**CERTIFICATE OF APPROPRIATENESS**

**Property:** 1811 Shearn Street, Tract 9, Block 304, Shearn Subdivision. The property includes a historic 880 square foot, one-story wood frame single-family residence and a detached garage situated on a 3,333 square foot (33'-4" x 100') interior lot.

**Proposal:** Alteration – Deferral *Revision* - Construct a 1,032 square foot two story addition at the original rear wall of the residence.

In August 2015, the applicant proposed a two-story addition to the rear of a one-story contributing residence. The HAHC expressed concerns over the lack of delineation between the original structure and the addition, the use of windows on the addition with more horizontally oriented proportions than those on the existing structure, windows on the second floor of the addition that did not align with those on the first floor, and a depth difference between the first and second floors of a proposed rear side porch. The HAHC moved to defer this item to allow the applicant time to make appropriate changes

WEST SIDE ELEVATION  
EXISTING

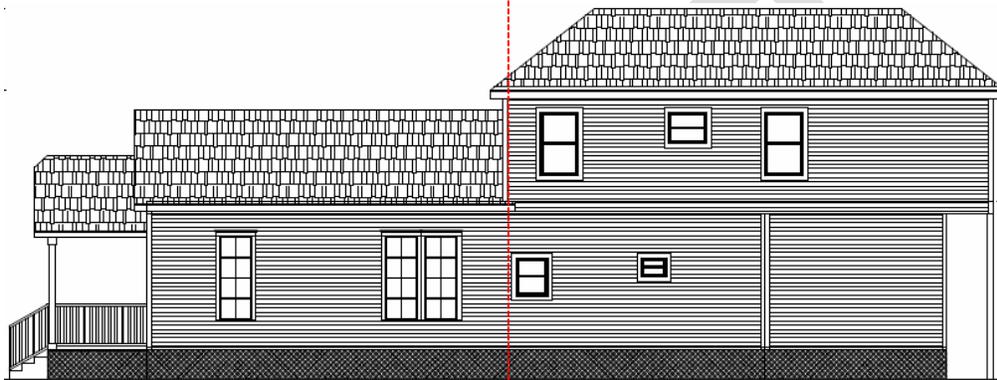
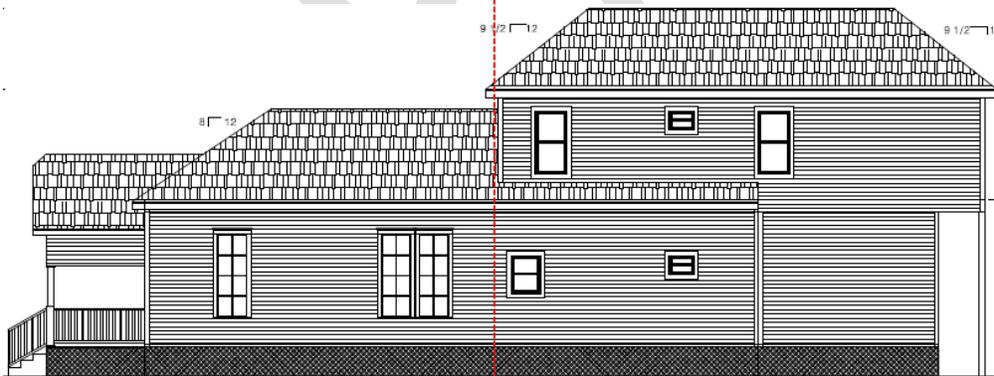
- Clarified that roof shingles are proposed to be used to visually separate the first and second floors of the addition.
- Added taller and narrower windows to the proposed addition.
- Aligned a pair of windows on the first and second floor of both sides of the addition.
- Adjusted the depth of the proposed second floor balcony so that the exterior wall aligns with the corresponding wall of the proposed outdoor kitchen on the first floor when viewed from the west.

**Proposed:** Adjusted the window of a the proposed second story game room so that it aligned with a first floor bedroom on the east elevation and aligned a first and second floor bedroom window on the west elevation.

SECOND FLOOR PLAN

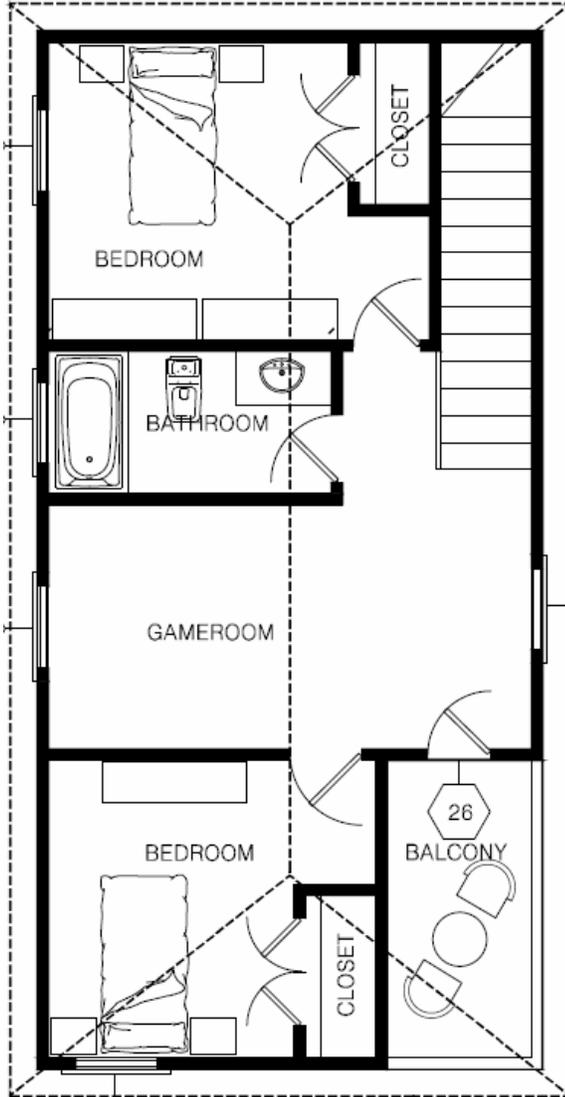
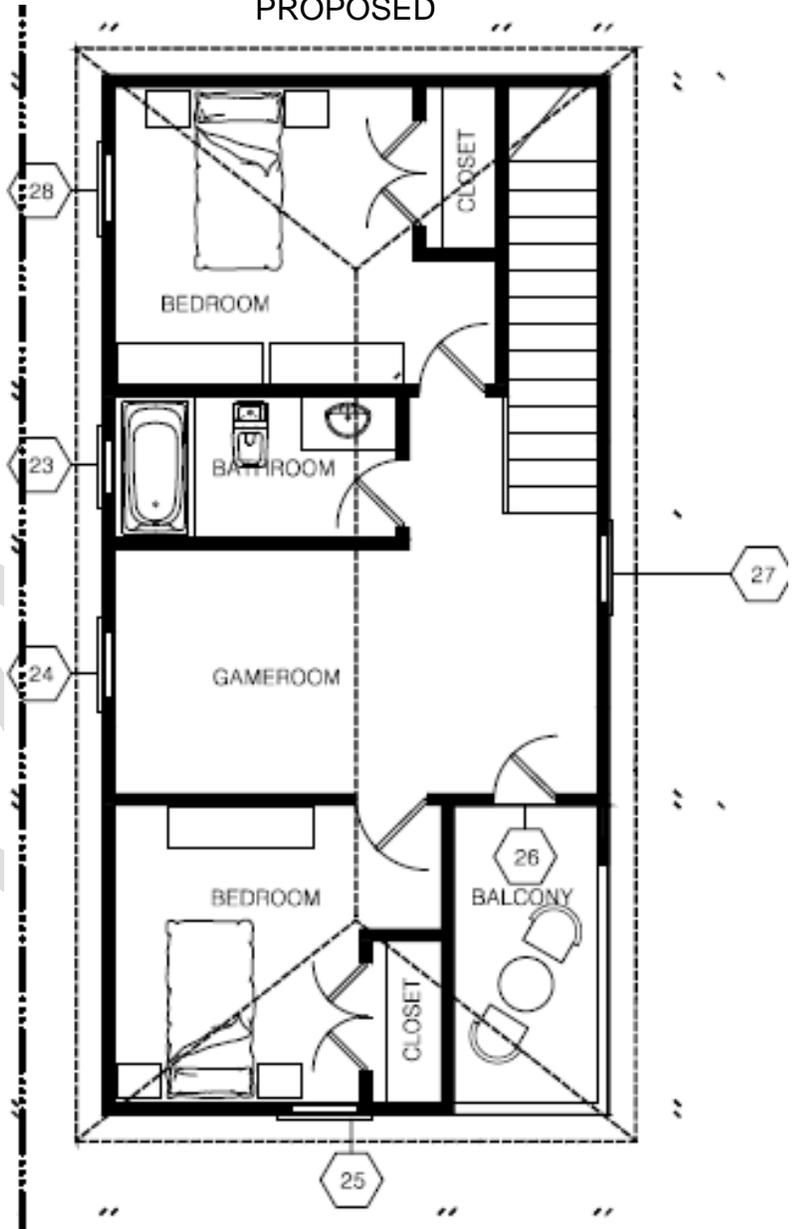
**Proposed:** The rear wall of the proposed addition's second floor balcony has been adjusted to line up with the rear wall of the proposed outdoor kitchen on the first floor. The applicant has also added a strip of roofing material to delineate the first and second floor of the addition.
